02.00 VARIOUS ITEMS - PROPOSED AMENDMENTS
02.15 SOUTH ELEVATION

Planning Application 2020/1310/P

02.00 VARIOUS ITEMS - PROPOSED AMENDMENTS
02.16 NORTH ELEVATION

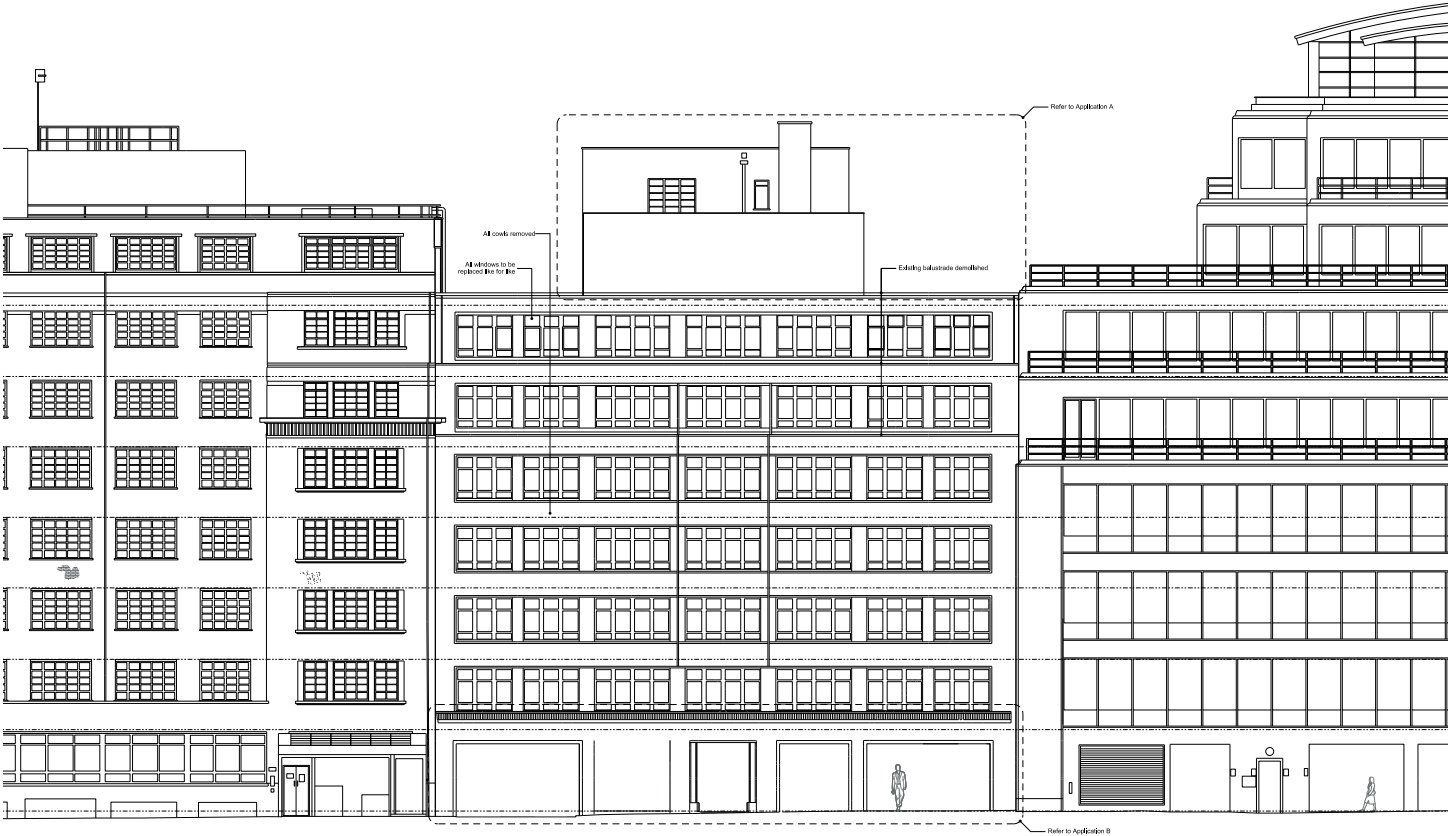
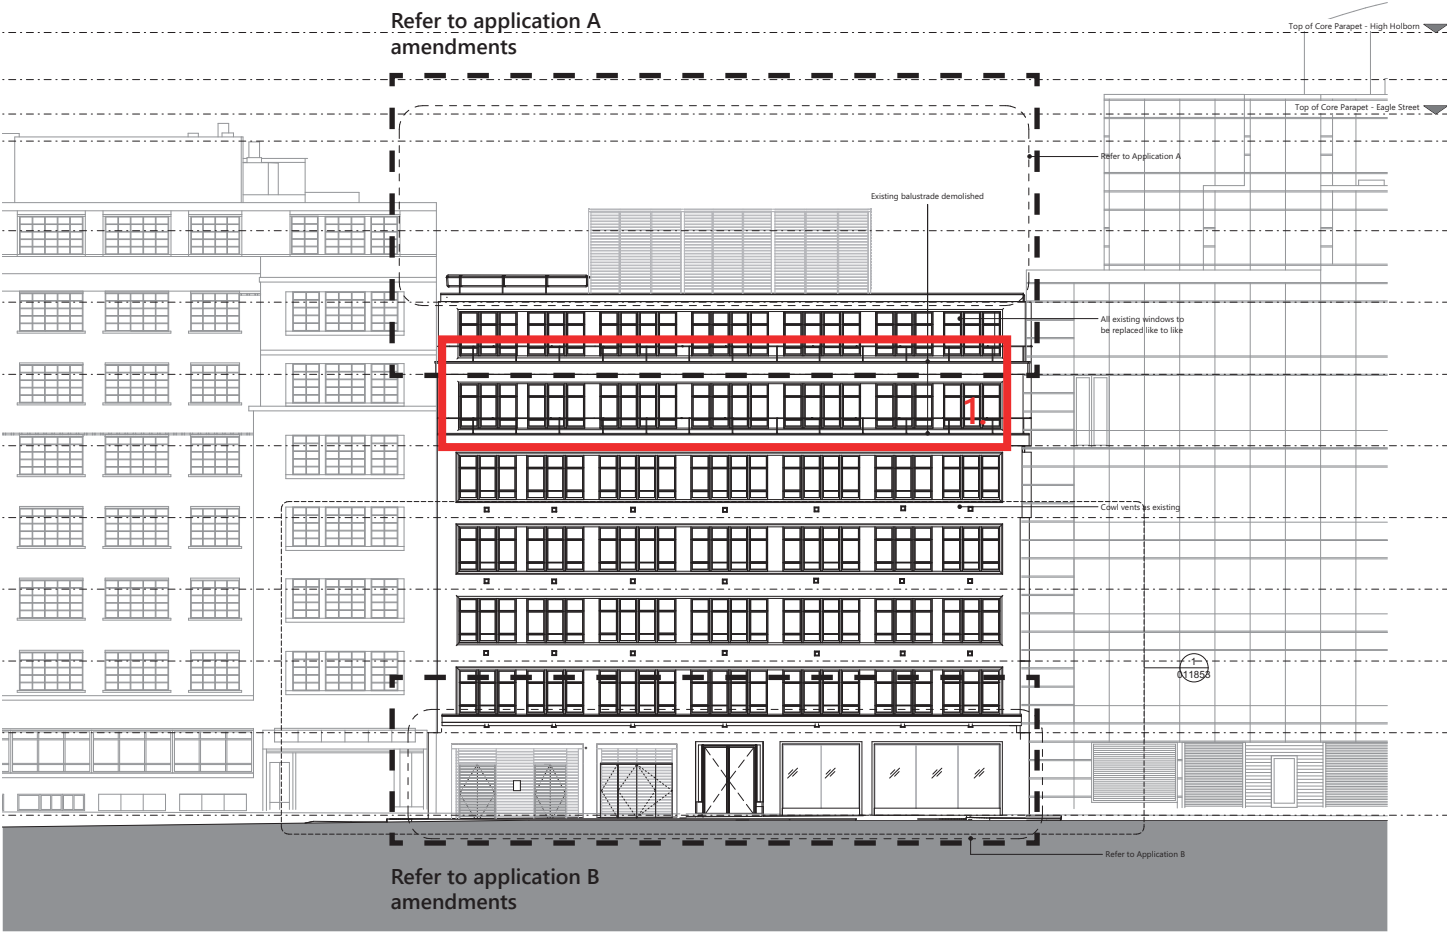
- 1. Railings as existing

02.00 VARIOUS ITEMS - PROPOSED AMENDMENTS
02.17 EAST ELEVATION

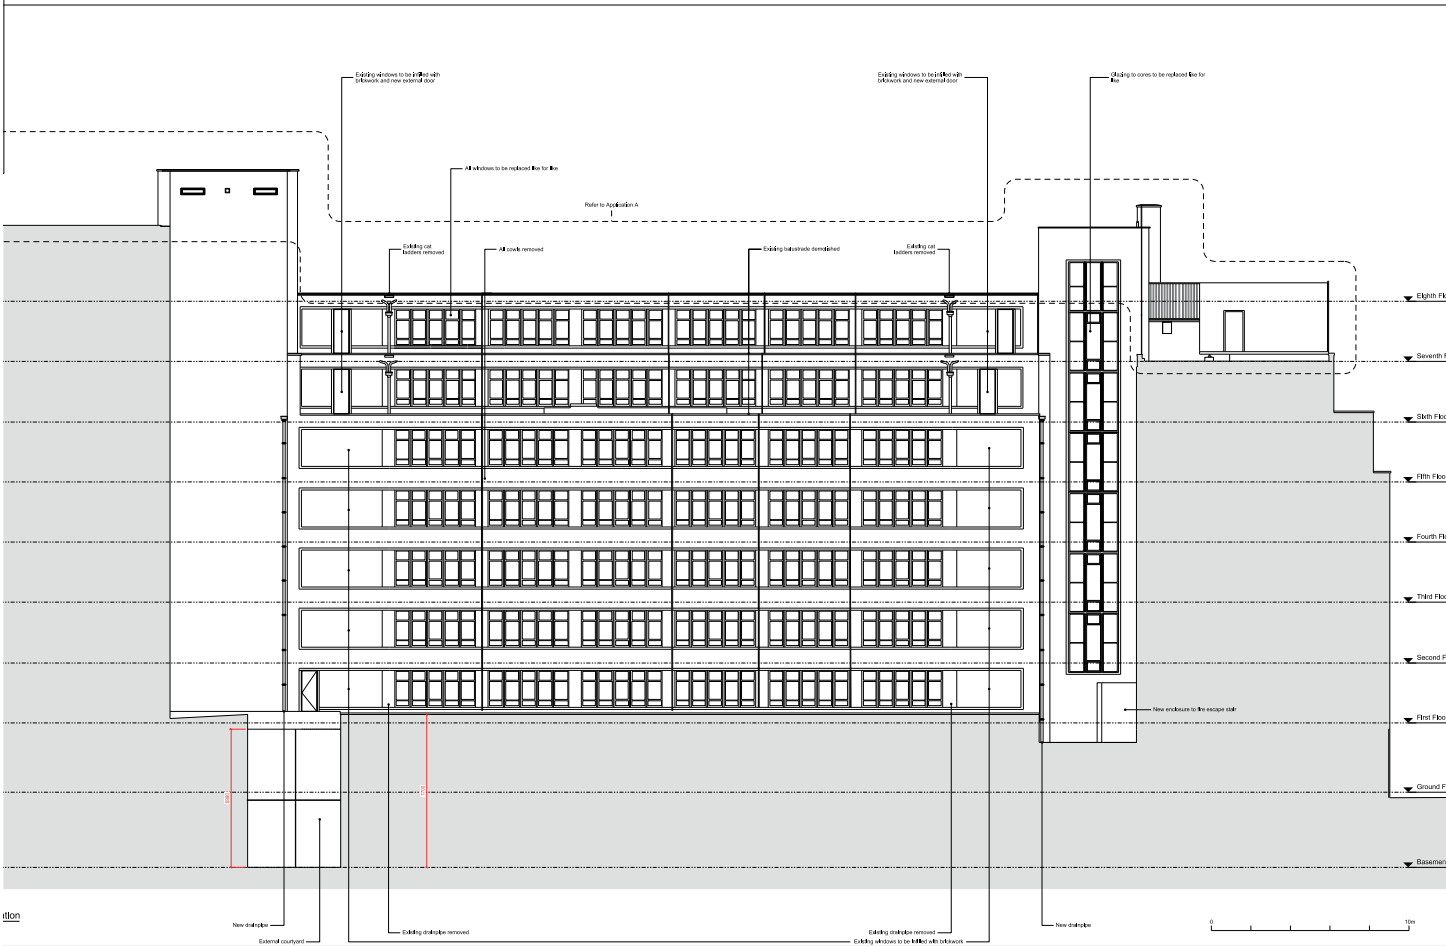
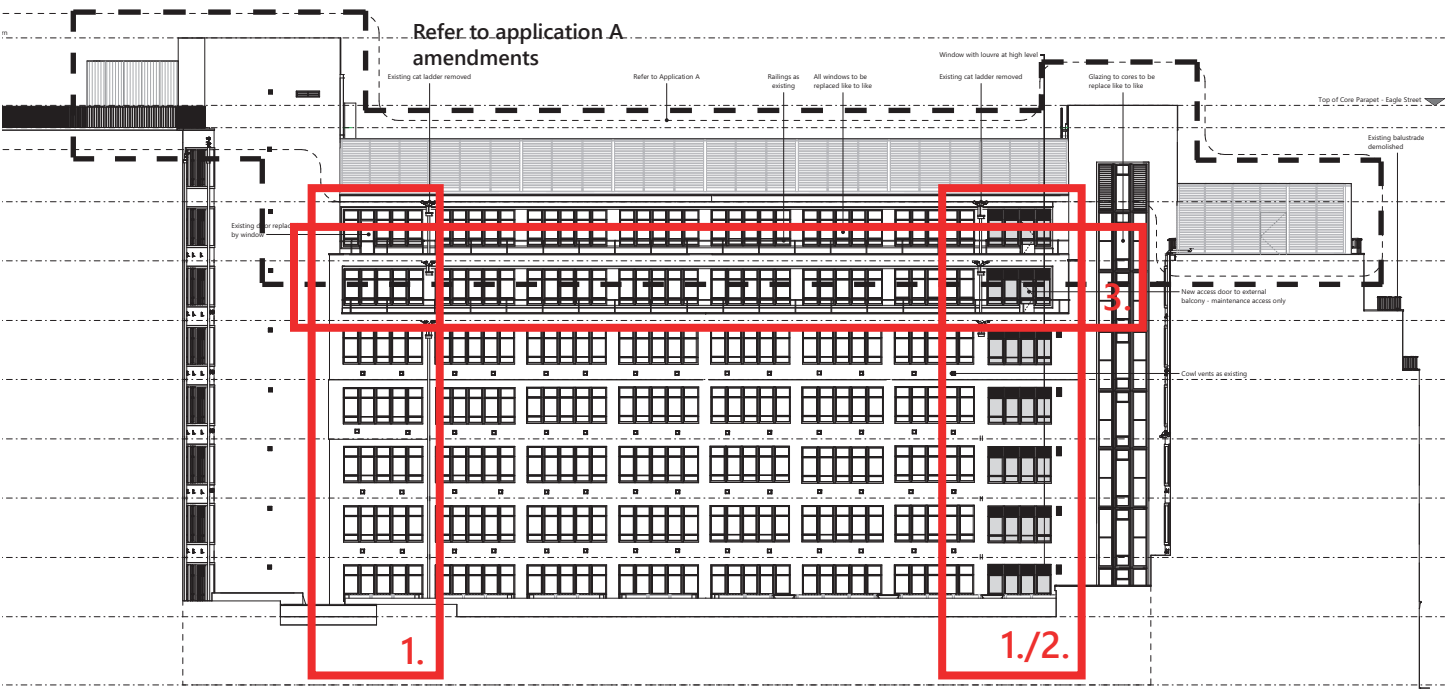
- LINK BLOCK
1. Window infills omitted.
 2. Louvred panels at high level.
 3. Railings as existing

02.18 WEST ELEVATION

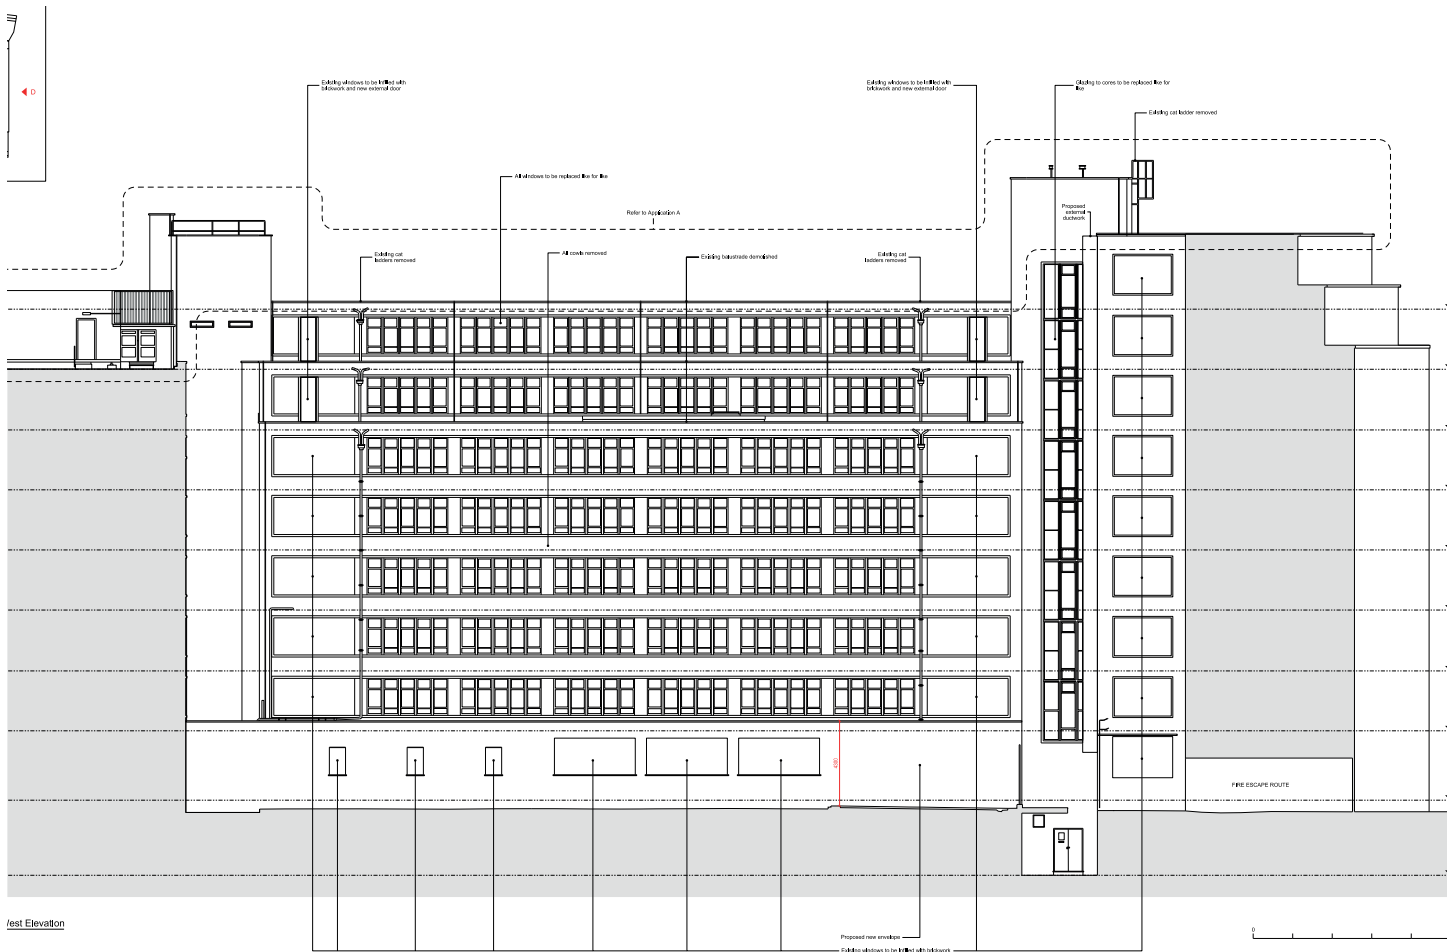
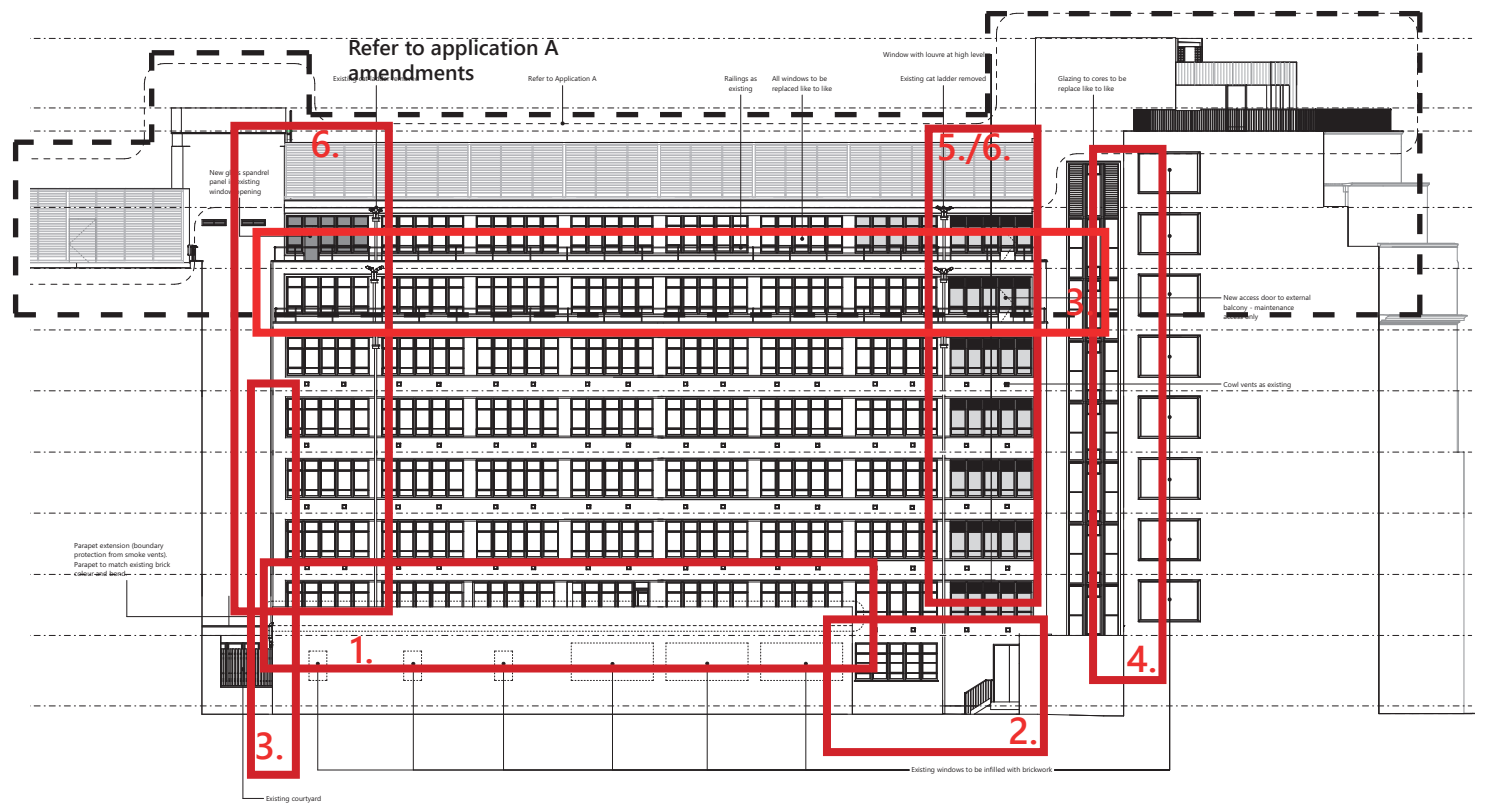
1. New parapet. Colour and material to match existing. Require for the fire strategy due to boundary condition
2. Ground floor infill omitted. Courtyard as existing. New fire exit added.
3. Data riser omitted.
4. Kitchen Extract Duct omitted.
5. Louvred panels at high level.
6. Window infills omitted.

02.19 HOLBORN NORTH ELEVATION

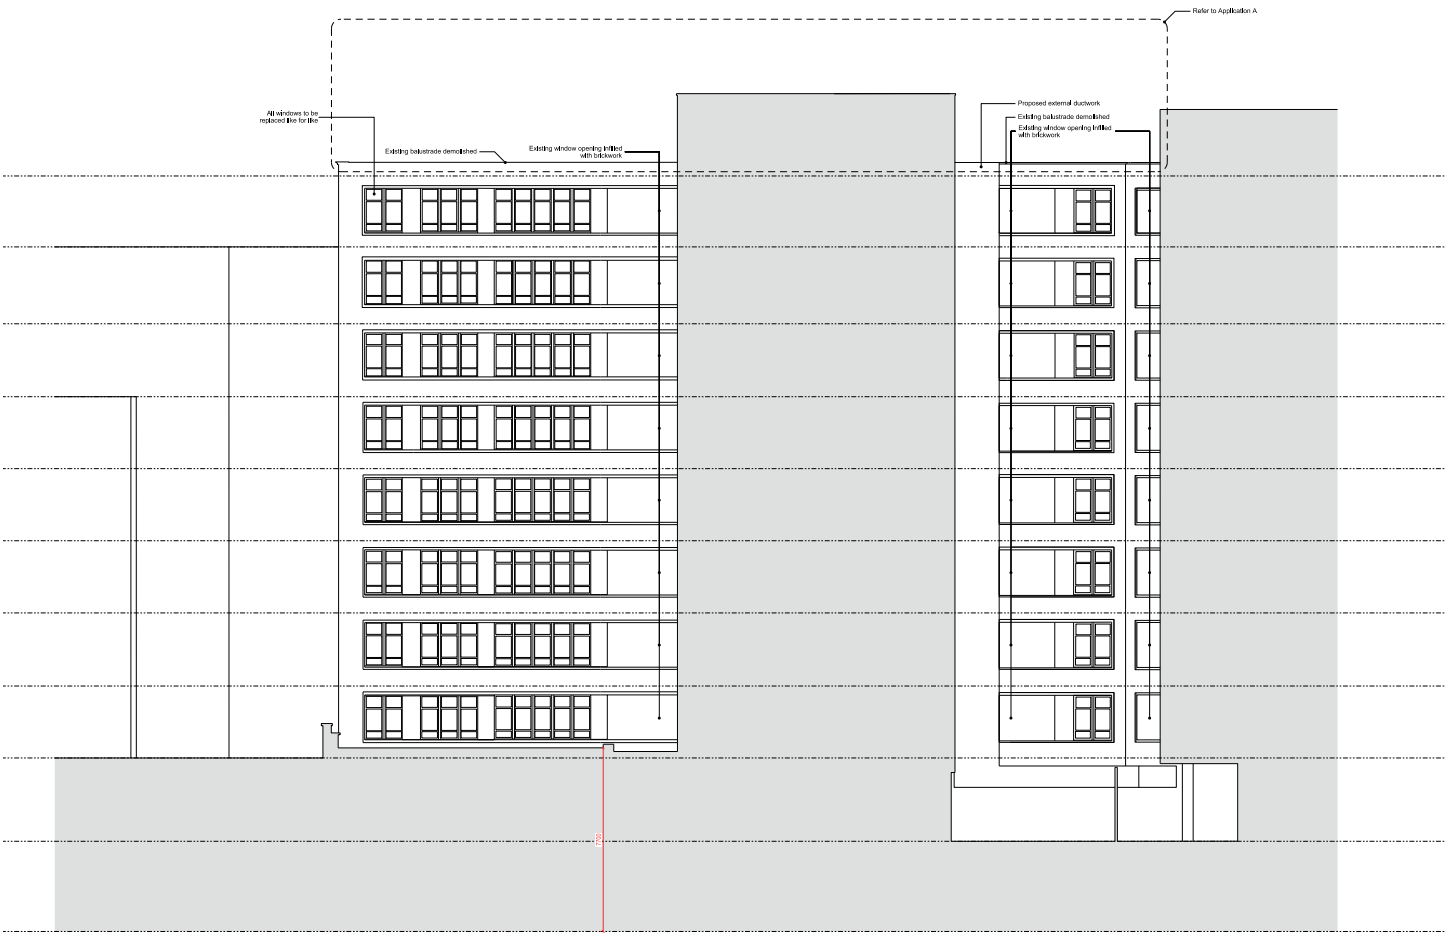
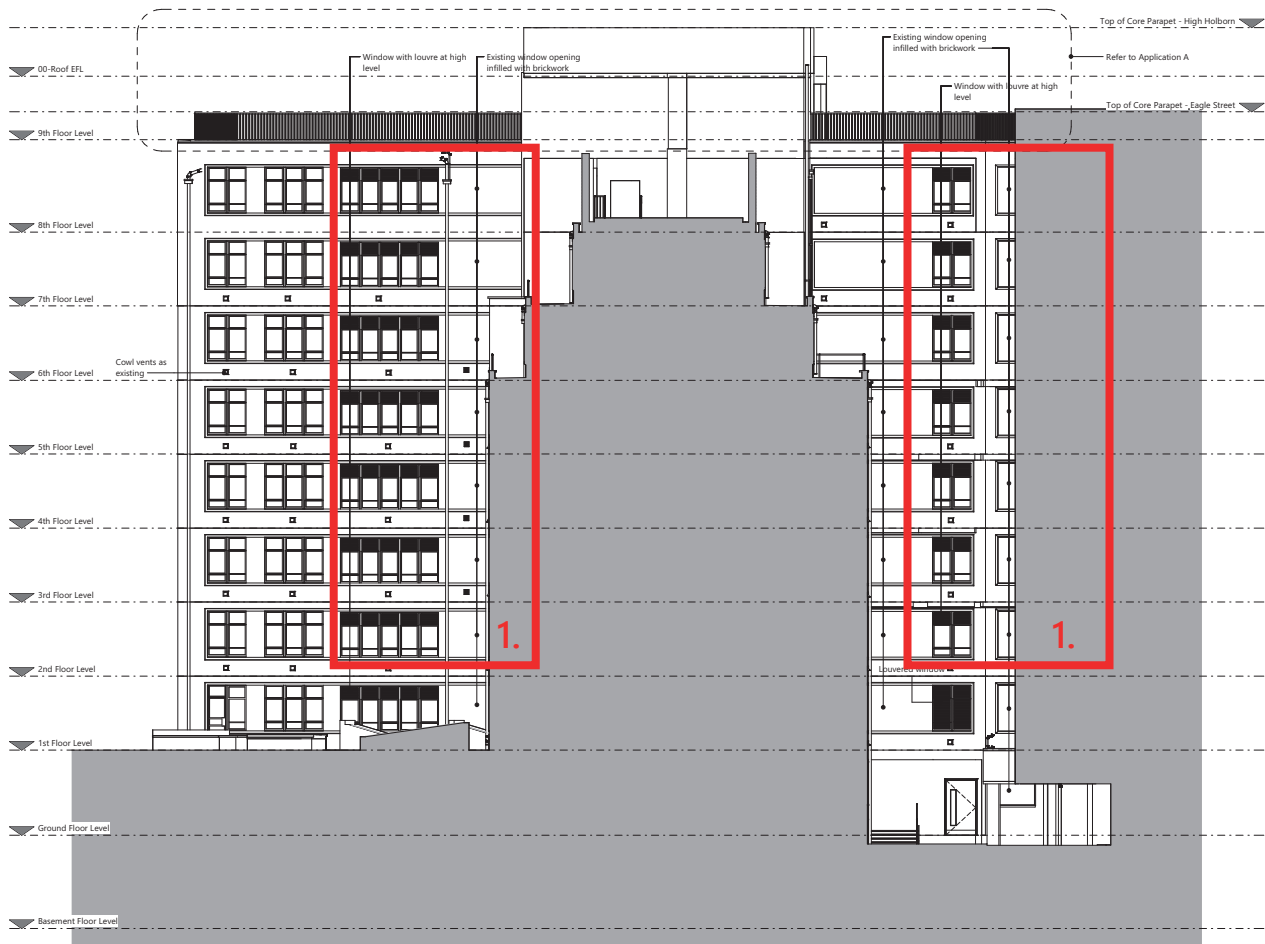
HIGH HOLBORN BLOCK
1. Louvred panels at high level.
